Re: Product change notification for Harwin product.

There has been a change to the tape pocket design on the following products:

Old pocket orientation

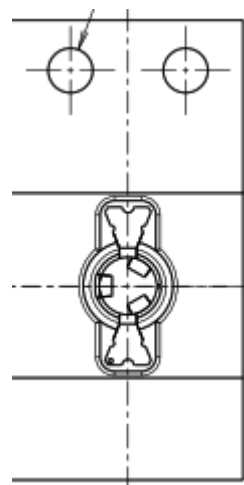
Part Number	Tape Width change	Technical Drawing
S9111-45R	From 12mm to 16mm	https://content.harwin.com/m/2d62dc5e5c4be546/original/DRG-02694-Technical-Drawing-Datasheet-S9111R-pdf.pdf
S9121-45R	From 12mm to 16mm	https://content.harwin.com/m/70cd4d27f5204ee1/original/DRG-02704-Technical-Drawing-Datasheet-S9121R-pdf.pdf
S9131-45R	From 12mm to 16mm	https://content.harwin.com/m/270d1f232a7b6264/original/DRG-02703-Technical-Drawing-Datasheet-S9131R-pdf.pdf
S9141-45R	From 12mm to 16mm	https://content.harwin.com/m/2aea749f5b91459c/original/DRG-02705-Technical-Drawing-Datasheet-S9141R-pdf.pdf

The contacts have changed orientation in the tape:

This packaging improvement minimises the risk of these miniature low-profile contacts turning or twisting within the pocket - increasing assembly efficiency.

This revised packaging method has been tested and continues to meet the EIA-481 requirements. The Sycamore Contact sockets are not affected and remain unchanged.

All new and existing orders at Harwin for S9111-45R product will be supplied in the new tape and reel packaging. Reels with the new orientation pockets will be clearly labelled for a minimum of 12 months. Using the new orientation will require a change to your Pick/Place machine setup.
